CITY PLAN COMMISSION**THURSDAY, APRIL 24, 2025****FILE NUMBER:** S245-136**SENIOR PLANNER:** Sharmila Shrestha**LOCATION:** Veterans Drive, north of Talco Drive**DATE FILED:** March 26, 2025**ZONING:** R-5(A)**CITY COUNCIL DISTRICT:** 8**SIZE OF REQUEST:** 1.00-acre**APPLICANT/OWNER:** Wisehouse Investment Group, LLC

REQUEST: An application to replat a 1.0-acre (43,528-square foot) tract of land containing all of Lots 13 and 14 in City Block E/6855 to create four 10,882-square foot lots on property located on Veterans Drive, north of Talco Drive.

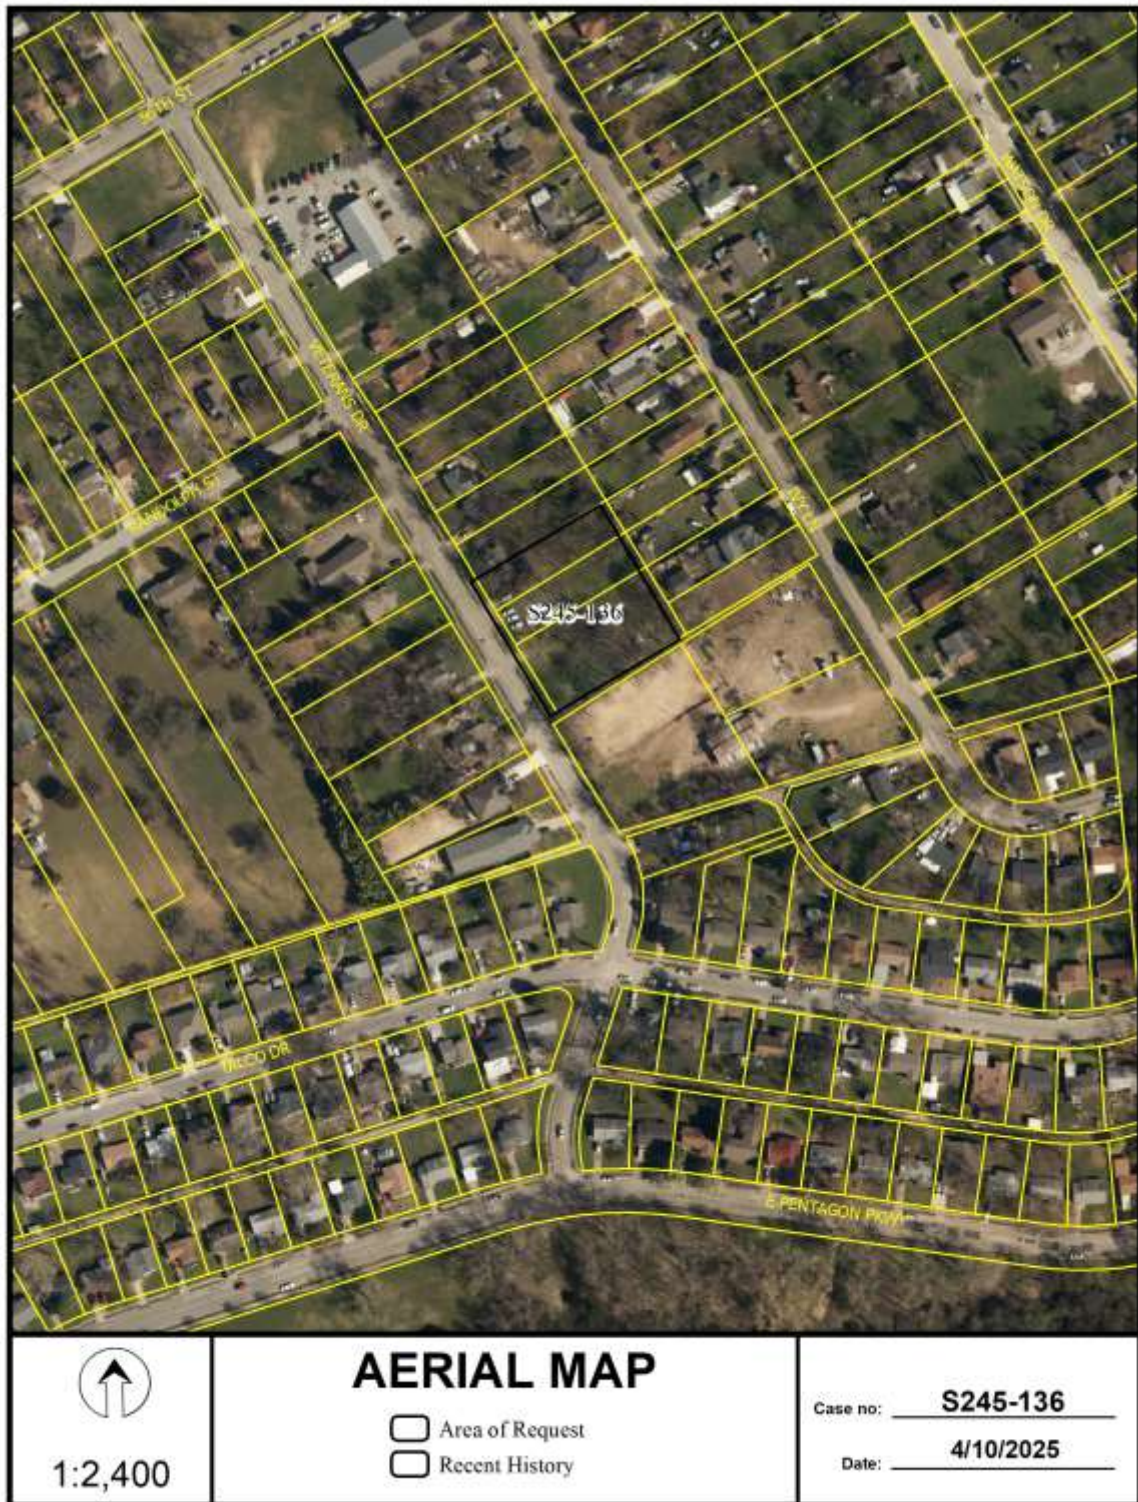
16. On the final plat, dedicate 28 feet of right-of-way (via fee simple or street easement) from the established centerline of Veterans Drive. *Sections 51A-8.602(c), 51A-8.604(c) and 51A-8.611(c).*

17. On the final plat, determine the 100-year water surface elevation across this addition.
18. On the final plat, dedicate floodway easement, floodway management area or floodway easement (within common area), with the appropriate easement statement included on the face of the Plat. 51A 8.611(d); DWU Floodplain Management; Drainage Design Manual Addendum V

20. On the final plat, specify minimum fill and minimum finished floor elevations. *Section 51A-8.611(d), Trinity Watershed Management.*
21. On the final plat, show the natural channel set back from the crest of the natural channel. *Section 51A-8.611(d), Trinity Watershed Management.*

29. Prior to final plat, compliance with City's Street lighting standards including illumination standards, material, installation, and activation per Street Design Manual.
30. On the final plat, identify the property as Lots 13A, 13B, 14A, and 14B in City Block E/6855.
